**ACCESSIBILITY
SURVEY & REPORT**
for

COSTA MESA CIVIC CENTER

77 - 99 Fair Drive
Costa Mesa, California

ITEM: Accessibility Survey and Report

CC-2

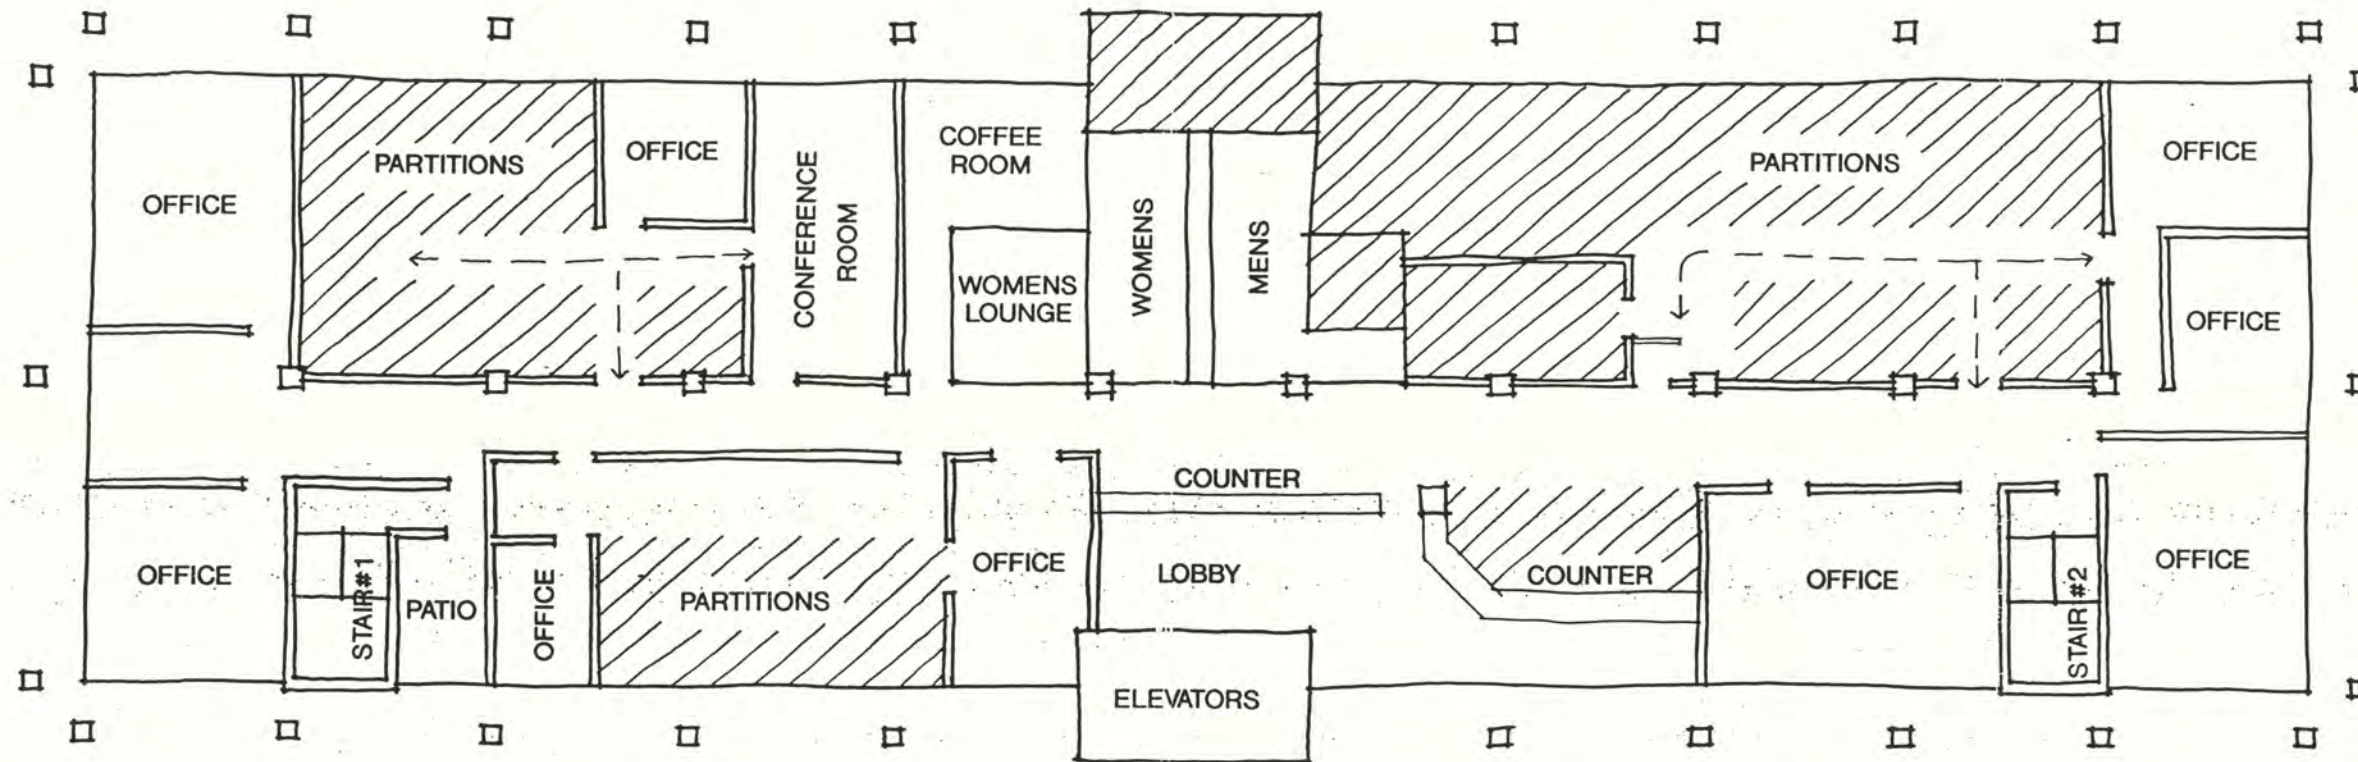
Item Location/ Plan No.	ADA Deficiency Description	ADA Code Reference	ADA Priority	Correction Description	Corr. Cost Est	Readily Ach'vble? <high-----low->	Corr. Priority
2	CC-2 Insufficient "passing space" provided in front of City Clerk's office, measuring 57" clear.	4.3.4	2	Passing space required in front of City Clerk's counter to be 60" clear. Move counter back, or modify counter, in order to provide clearances required.	\$640	<.1..2..3..4..5.>	
3	CC-2 No access to Council Chambers auditorium from inside City Hall Building, due to interior stairs. Note that the ADA stipulates stairs shall not be a part of an accessible route. An accessible route to restroom facilities, equivalent to the route for the general public, is not provided.	4.1.3(1) 4.3.8 4.5.2 4.1.6(1)(f)	2	Provide wheelchair or platform lift as a means of accessible vertical access. (Note: Means of access (accessible route) via exterior route is only feasible if such route is designated route for the general public. The current route is the interior corridor.)	\$12,000	<.1..2..3..4..5.>

4	CC-2 Terrazzo flooring in main entrance lobby areas is slippery when wet.	4.3.6 4.5	2	Provide abrasive flooring surface in lobby and other areas which are subject to moisture accumulation.	\$5,500	<.1..2..3..4..5.>	
5	CC-2 Excessively protruding objects, projecting into accessible route, walks, and corridors, deficient as follows: <ul style="list-style-type: none"> In Council Chambers, counter at back of room projects 12". In Council Chambers, bracket for display board projects 5". In Council Chambers, podium extension project 12". 	4.1.2(3) 4.4.1	2	The ADA stipulates that objects shall not project greater than 4" into walks or corridors, which are above 27" from finish floor. Remove deficient protruding objects, and/or modify to comply with ADA criteria. There are essentially two means of correcting these deficiencies: 1) Remove or modify the object to project no more than 4" or 2) Construct a furring below the object which is below 27" from finish floor. (In this way, a person with a sight disability using a cane may encounter the object prior to physically contacting it).	\$1,710	<.1..2..3..4..5.>

CC-3

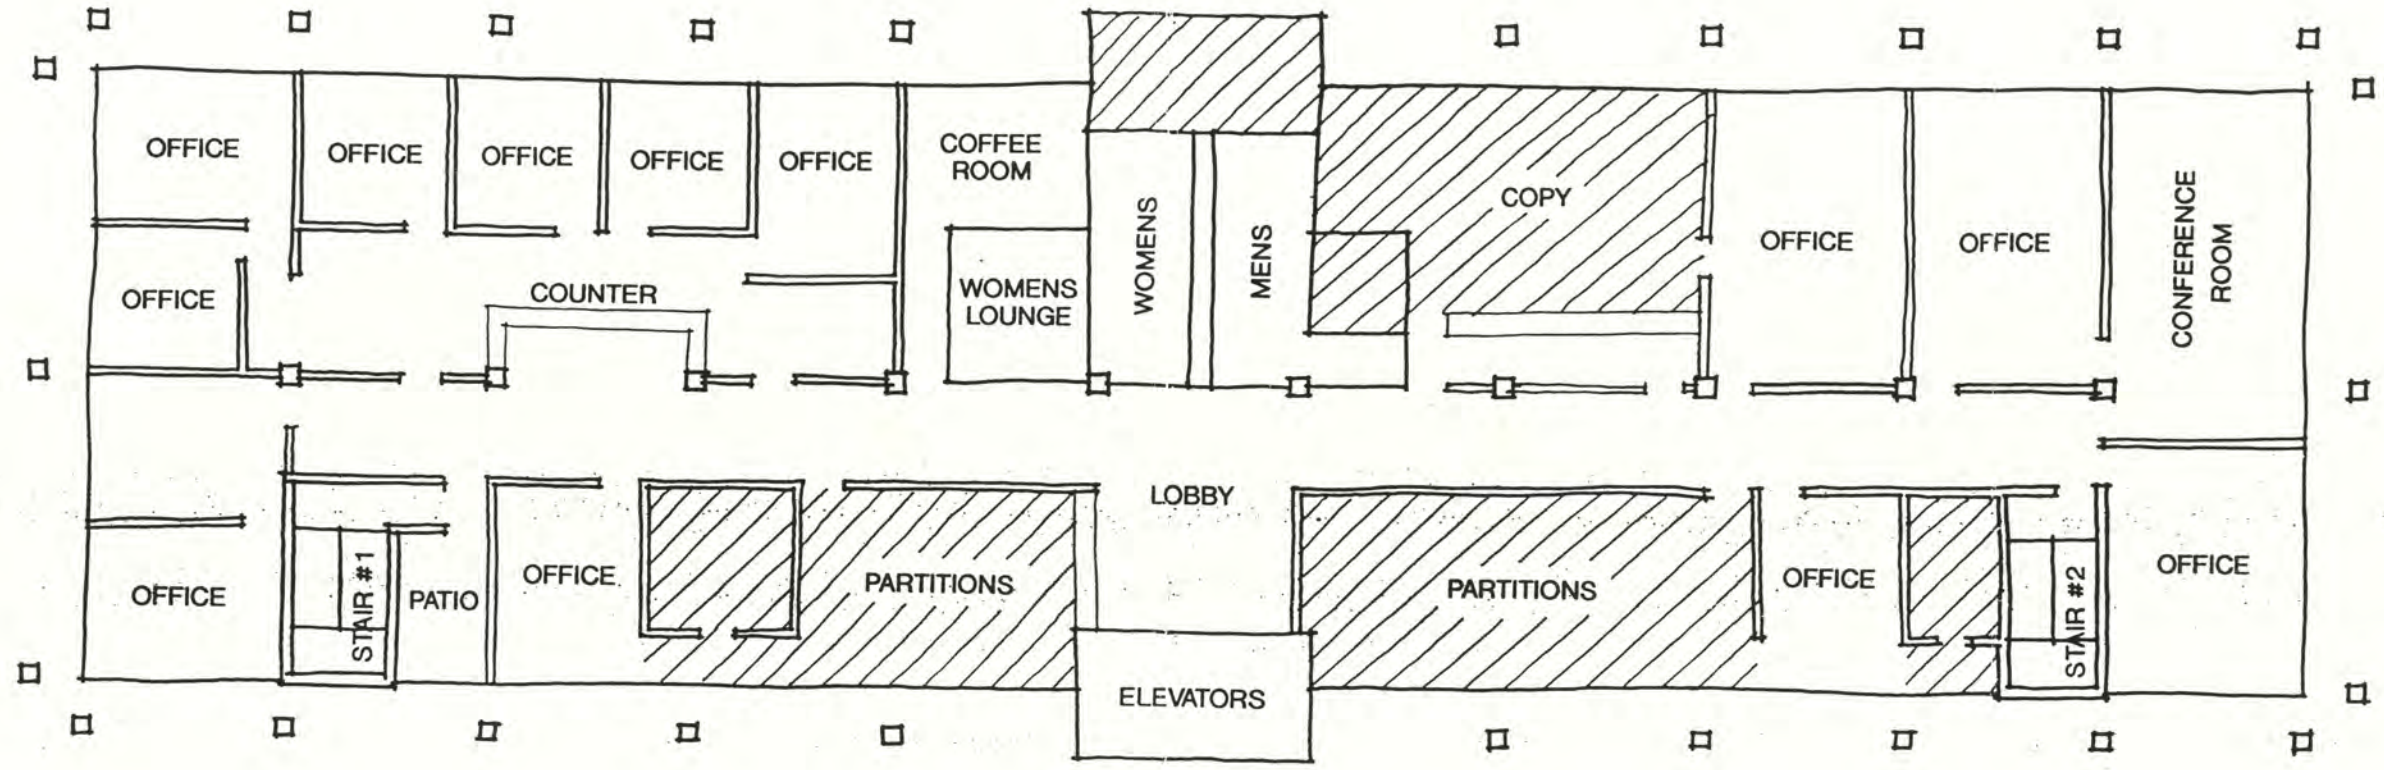
CITY HALL SECOND FLOOR							
8	<ul style="list-style-type: none"> Insufficient clear minimum width, at the following locations: In Building Department at plan storage in corridor across from xerox machine, measured at 29" clear. Route leading to plan checker's offices, measured at 26" and 15-1/2" clear into offices. 	4.3.3	2	Rearrange furniture and/or moveable partitions to provide a minimum clear width of 36".	\$200	<.1..2..3..4..5.>

CC-5

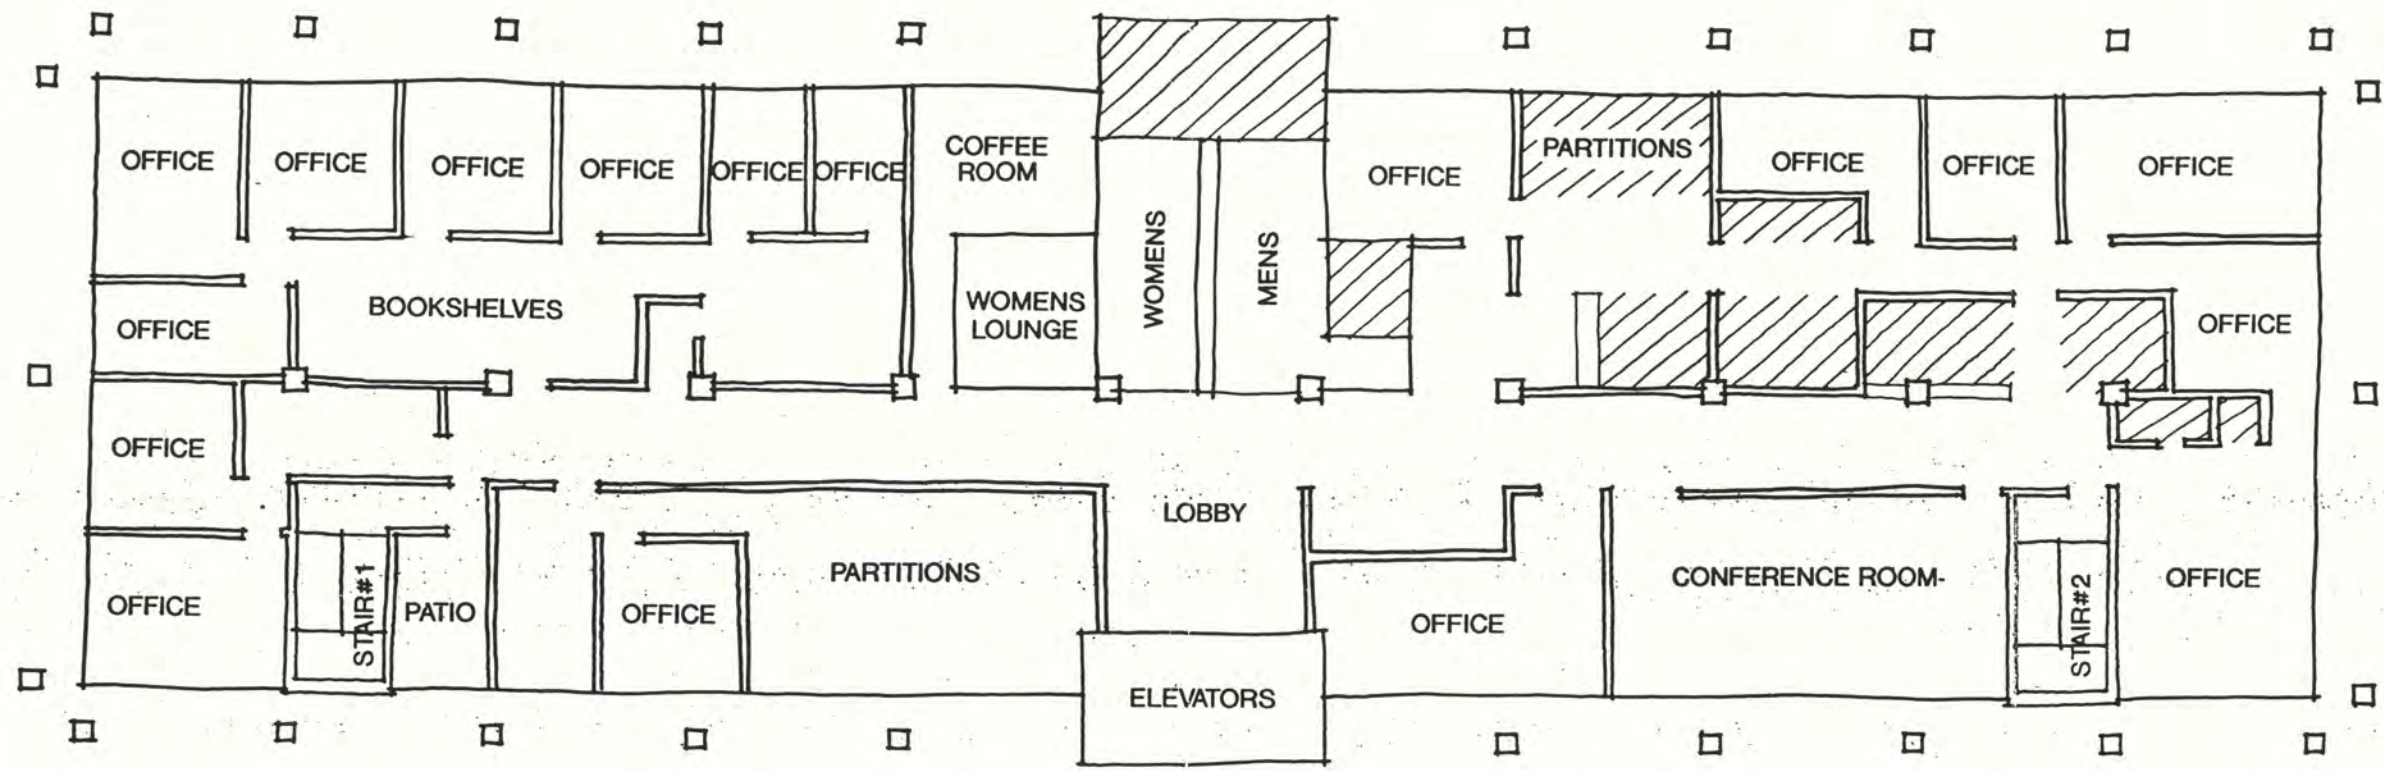
Item Location/ Plan No.	ADA Deficiency Description	ADA Code Reference	ADA Priority	Correction Description	Corr. Cost Est	Readily Ach'vble? <-high-----low->	Corr. Priority
CITY HALL FOURTH FLOOR							
14	CC-5 Insufficient minimum clear width provided at the following locations: <ul style="list-style-type: none"> In Transportation Services area, "hallway" crated by moveable partitions measures 33-1/2" clear. In Project Administration area, a clearance of 33-1/2" exists into back offices between furniture and moveable partitions. In Engineering Department, access to Assistant City Engineer's office measures 28-1/2" due to file cabinets in Reception area. 	4.3.3	2	Rearrange furniture and moveable partitions to provide the minimum clear width of 36".	\$150	<.1..2..3..4..5.>	
15	CC-5 Insufficient minimum clear headroom, provided at the following locations: <ul style="list-style-type: none"> Cross brace above doorway in partition to Mike Waters' office, measured at 77" high. Suspended VCR/TV in conference room from ceiling, measured at 36". 	4.3.5 4.4.2	2	The ADA stipulates a minimum clear headroom of 80". Modify cross bracing above doorway into Waters' office accordingly. Construct cabinet below TV/VCR to provide adequate protection.	\$1,000	<.1..2..3..4..5.>

16	CC-5 In several areas in the main corridor, carpeting is in disrepair, with pleats or "bagged" portions being potentially hazardous.	4.5.3	2	Replace carpeting in excessively worn areas.	\$1,400	<.1..2..3..4..5.>
